**ATTACHMENT 4**  
**AREA WALK-BY CHECKLIST**

## Area Walk-By Checklists (AWCs)

**Table A-1: Area Walk-By Checklists**

Area # AUX, -15, CAL-AB-101 8-6-12 192

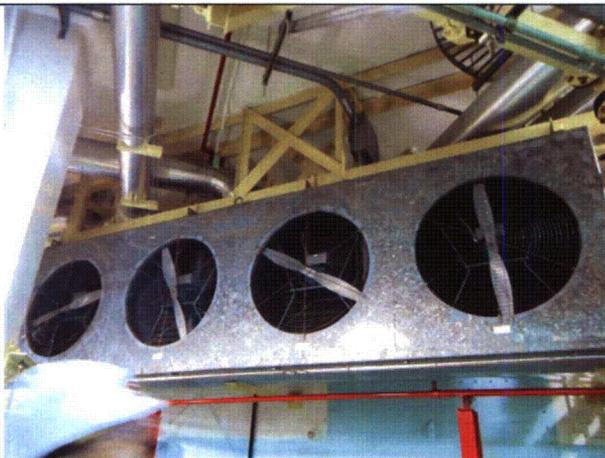
2. Does anchorage of equipment in the area appear to be free of significant degraded conditions? Yes  
*Observed that LPSI 21 is missing an anchor bolt. This condition has been evaluated by calculation CA02066.*

3. Based on a visual inspection from the floor, do the cable/conduit raceways and HVAC ducting appear to be free of potentially adverse seismic conditions (e.g., condition of supports is adequate and fill conditions of cable trays appear to be inside acceptable limits)? Yes  
*Cable trays are supported on walls and trapeze hangers, judged not to have any seismic concerns.*

5. Does it appear that the area is free of potentially adverse seismic interactions that could cause flooding or spray in the area? Yes  
*The overhead threaded fire piping is judged to be well supported and not a concern for spray or flooding.*

*Scaffolding and lead shielding is judged to be well supported, therefore not a seismic concern.*

Location (Bldg, Elev, Room/Area): Area : AUX, 27, CAL-AB-302

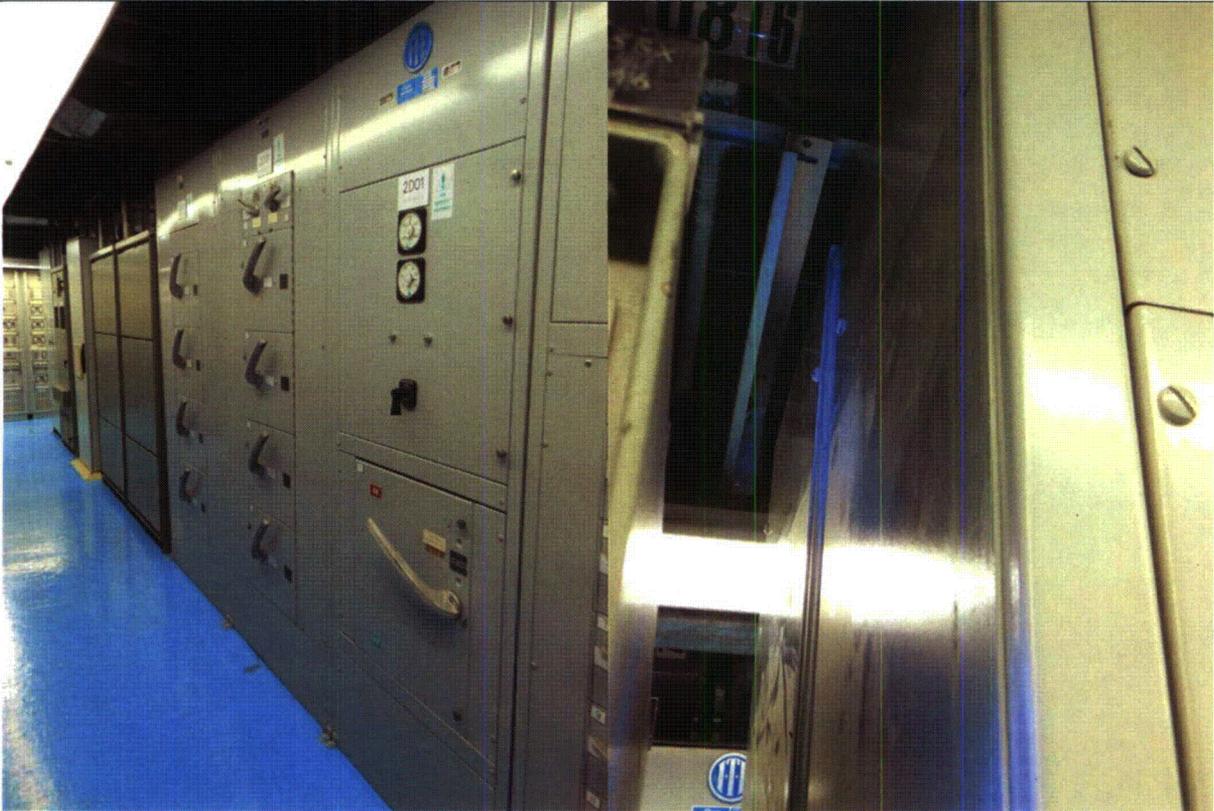
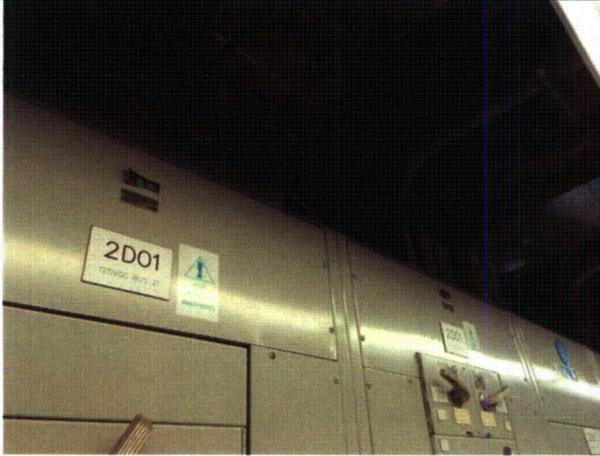
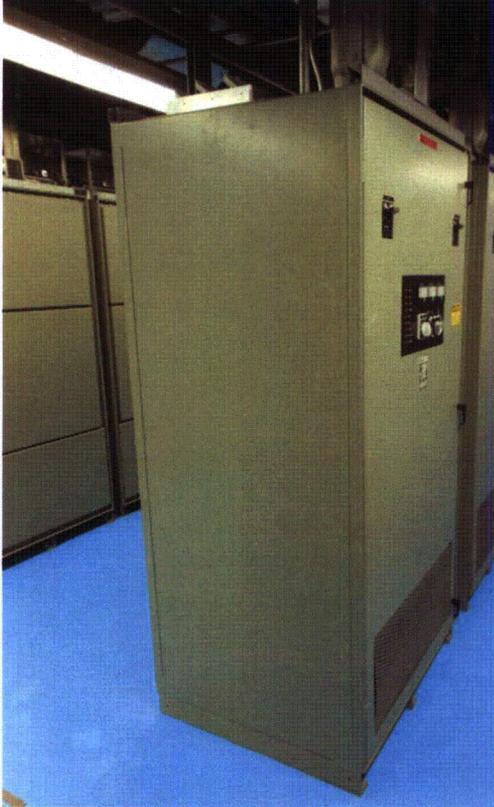
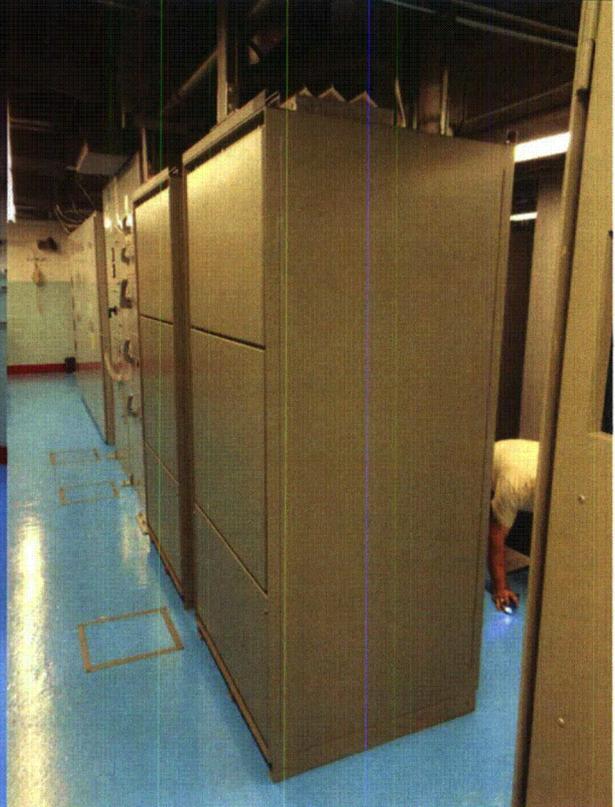
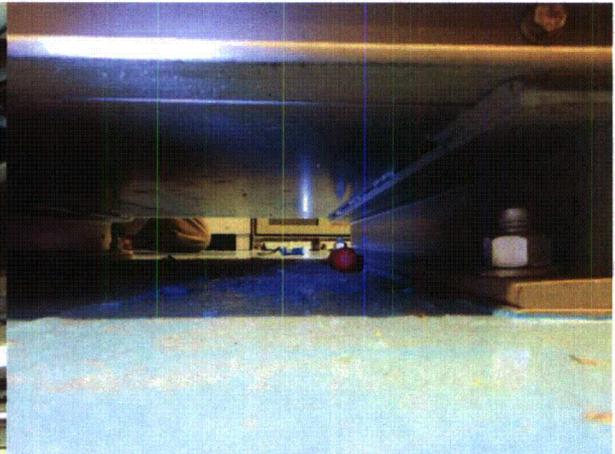
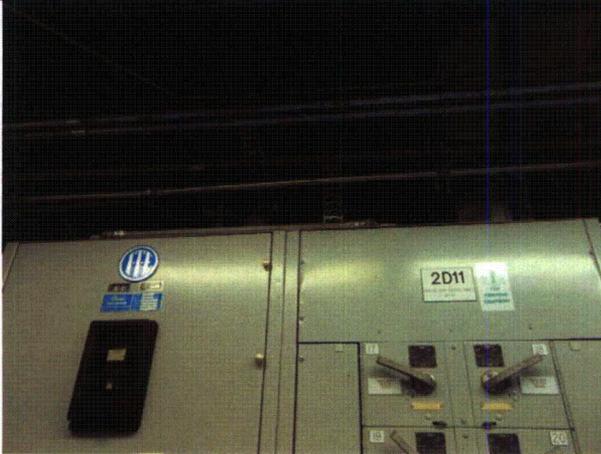
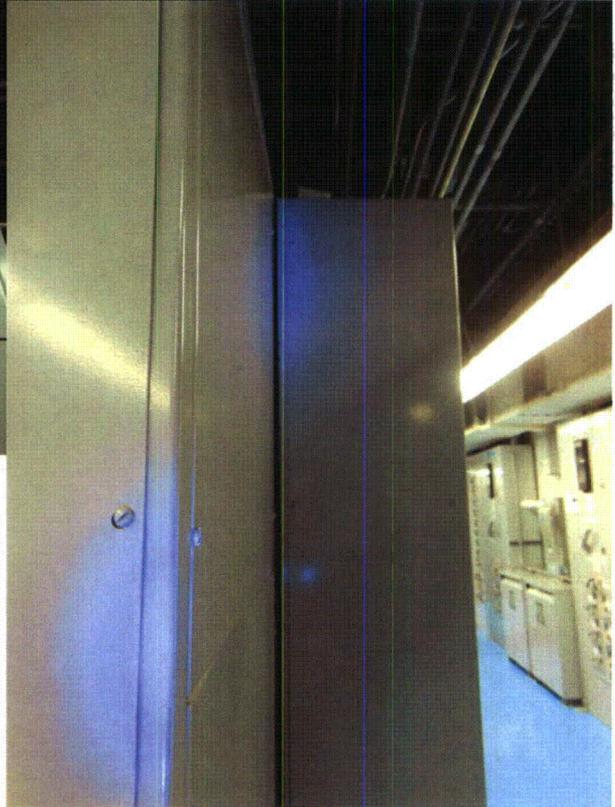
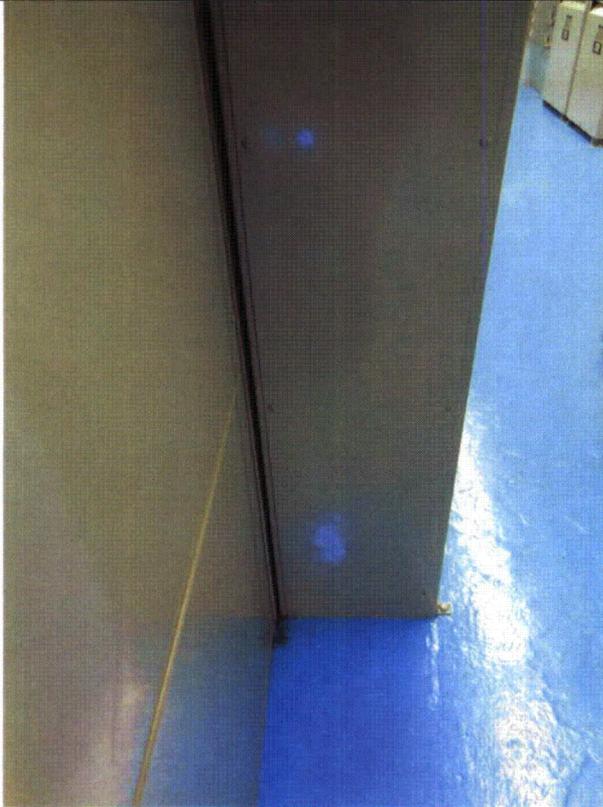
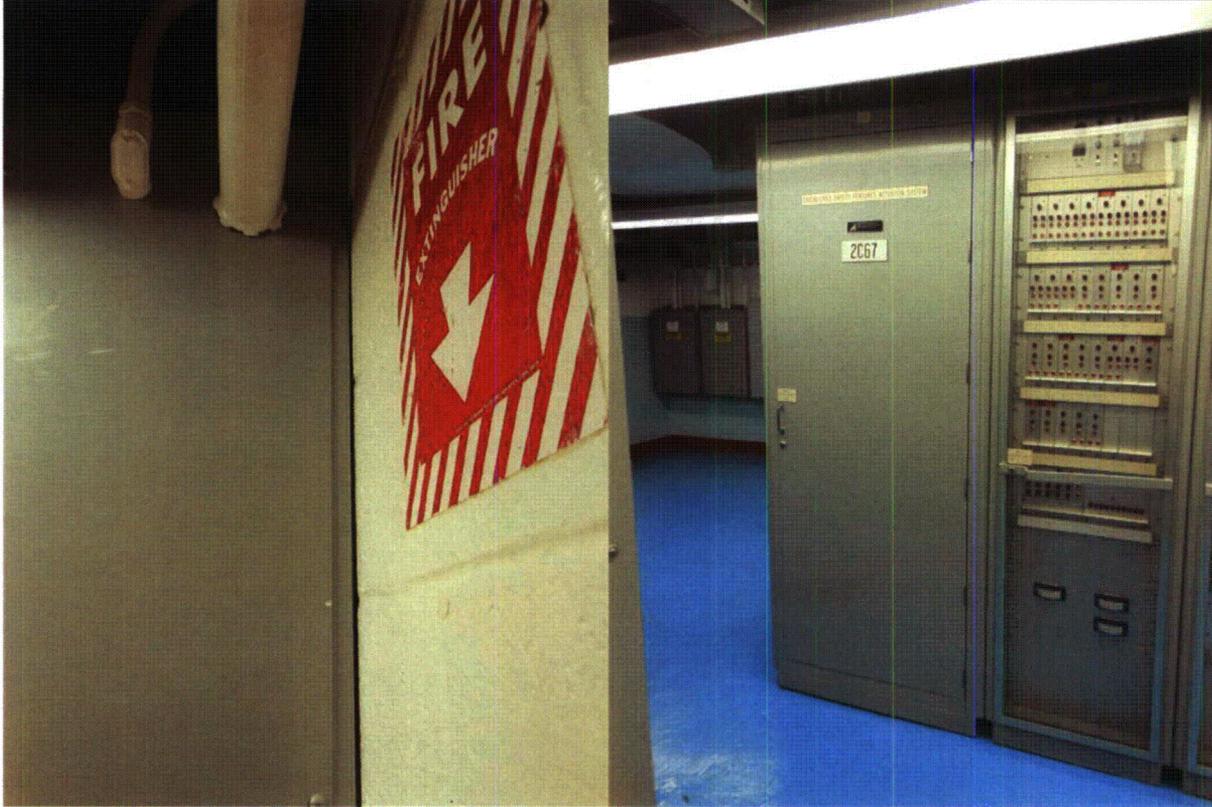
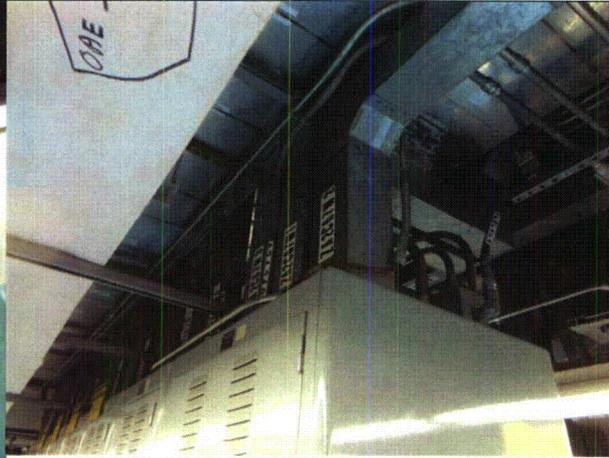
| 1. | <p>Does anchorage of equipment in the area appear to be free of potentially adverse seismic conditions (if visible without necessarily opening cabinets)?</p> <p><i>Observed panels mounted to masonry block wall. Masonry block walls, identified as T, S, N, AA and BB on drawing A-260, are safety-related and thus seismically rated per IE Bulletin 80-11.</i></p>  | Yes |
| 3. | <p>Based on a visual inspection from the floor, do the cable/conduit raceways and HVAC ducting appear to be free of potentially adverse seismic conditions (e.g., condition of supports is adequate and fill conditions of cable trays appear to be inside acceptable limits)?</p> <p><i>There are open ladder type cable trays, supported on either unistrut frames or a combination of unistrut and rod hanger frames or cantilever bracket off unistrut frames. Typically the cable tray is clipped to every 2nd or 3rd cantilever support bracket.</i></p>   | Yes |
| 4. | <p>Does it appear that the area is free of potentially adverse seismic spatial interactions with other equipment in the area (e.g., ceiling tiles and lighting)?</p> <p><i>Verify whether cabinets 2D02 and 2D14 are bolted together. Conduit from 2D12 is a 1/8" to 2Y10-80 &amp; 2D02 75-2208. 1/2" gap to 2Y01A and 1/4" gap to 2Y11 to Block wall.</i></p> <p><i>Evaluated using 8 Hz frequency for cabinets</i></p> <p><i>2% Damping Ratio, 1.5 PF</i></p> <p><i>Response Spectrum AB027D2N.dat</i></p> <p><i>A=0.25g</i></p> <p><i><math>D = 2 * (1.5 * 0.25 * 386) / (8 * 2 * 3.14)^2 = 0.11" &lt; 1/4" \text{ OK}</math></i></p> | Yes |

Location (Bldg, Elev, Room/Area): Area : AUX, 27, CAL-AB-311

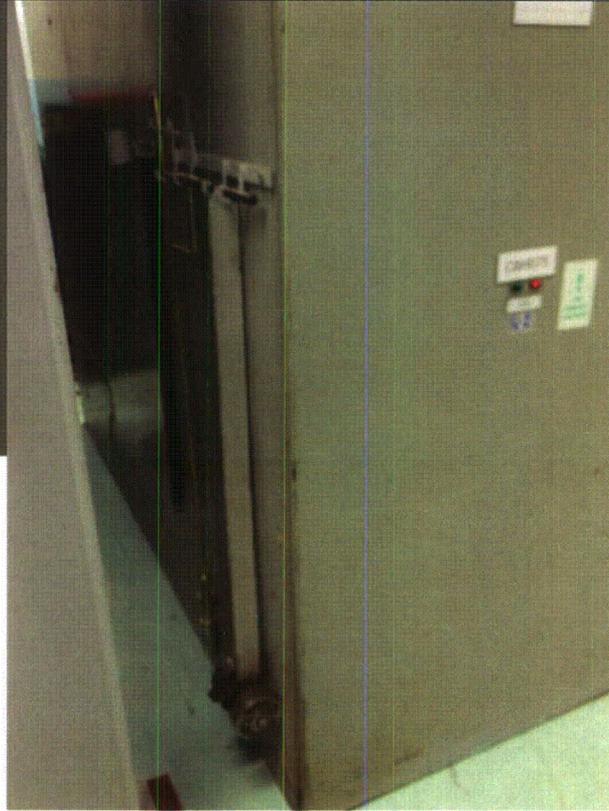
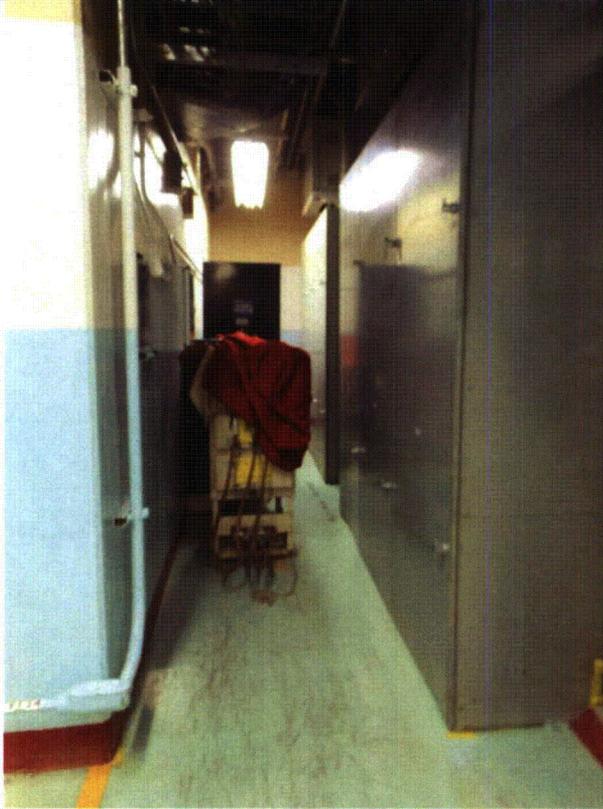
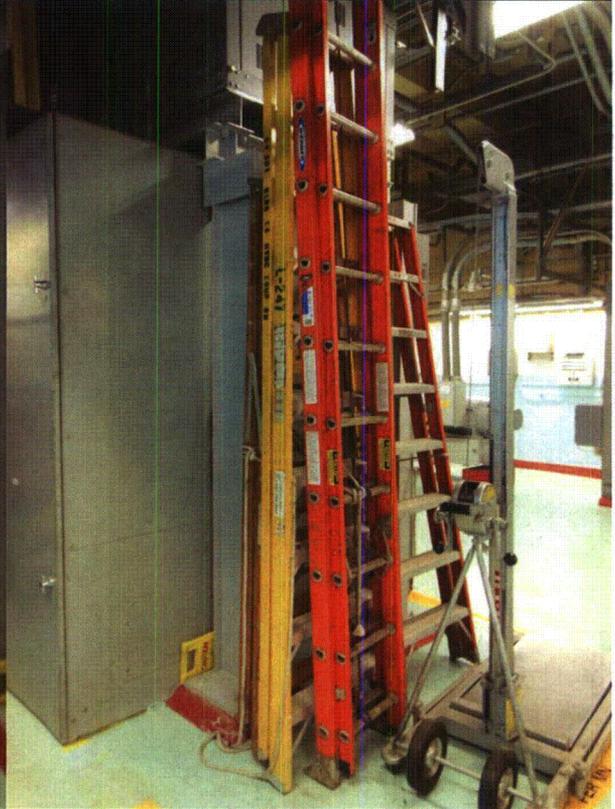
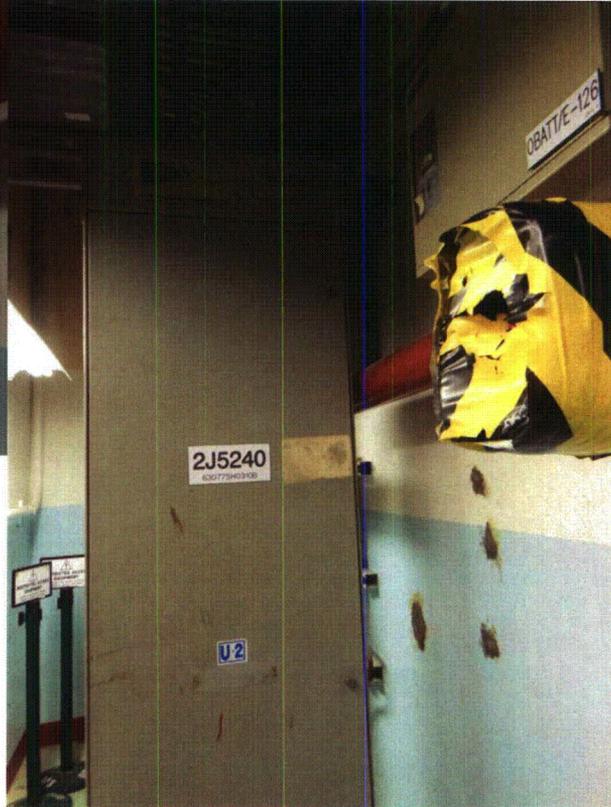
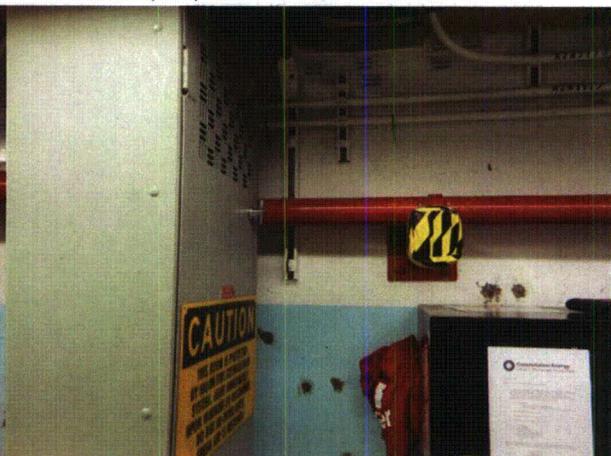
*Unistrut frames support open ladder type cable trays and some trays are supported on cantilever brackets with hook type end but no clips. Unistrut frames are also braced either knee bracing to the ceiling or back to the wall. Also, there are some cable trays supported on cantilever brackets that are braced back to the walls.*

*MCC 2N130 (PRESS HTRS) is 1/2" from a block wall.*

*$D = (1.5 \cdot 0.25 \cdot 386) / (8 \times 2 \times 3.14)^2 = 0.06" < 1/2" \text{ OK}$*

*480V Disconnect SW cabinet (2NB104, 116 and 121) is in contact with fire piping. The Fire piping is 3-1/2" outside diameter and spans at 11' between supports and cabinet is approx. centered. The cabinet dimensions are 20" x 60" x 90" high.*

*Consider the use of black pipe which is typical A-53. A-53 pipe has an allowable stress of 16 ksi at ambient, therefore the fire pipe will not be affect by the cabinet. Not a seismic concern*

*There is a tool hanging on RCP 22A P01 (Trip sensitive Equipment) may be banging on cabinet during a seismic event, this is a potential problem. CR-2012-08676*

| 7. | Does it appear that the area is free of potentially adverse seismic interactions associated with housekeeping practices, storage of portable equipment, and temporary installations (e.g., scaffolding, lead shielding)?<br><i>The equipment that is stored in the storage area will roll into each other, but not into cabinet RCP 22AP01, therefore not a concern. However it is recommended that better tie offs to provided.</i> | Yes |

Area # AUX, 45, CAL-AB-408 8-8-12 144

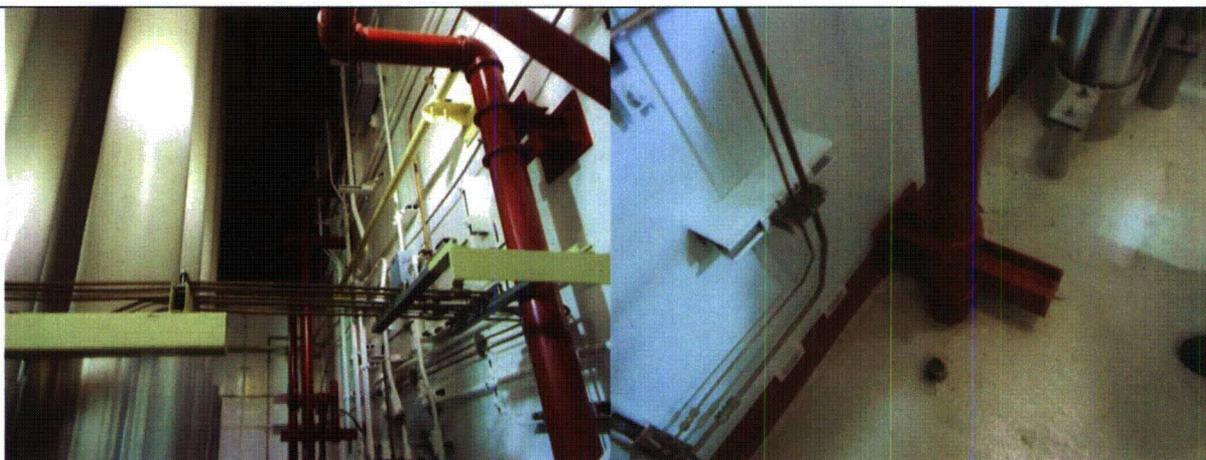
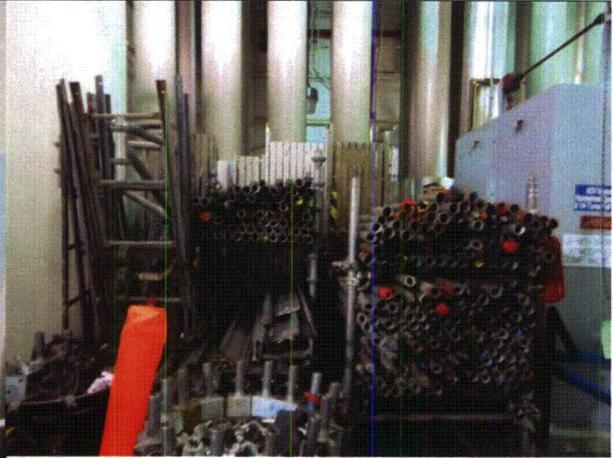
*There is scaffold part staging behind valve 2MS-3938-CV. The staging consist of racks those seismic adequacy is questionable. The racks may move and strike a drain line and MSS valves enclosure, therefore a potential seismic concern. CR-2012-009724*
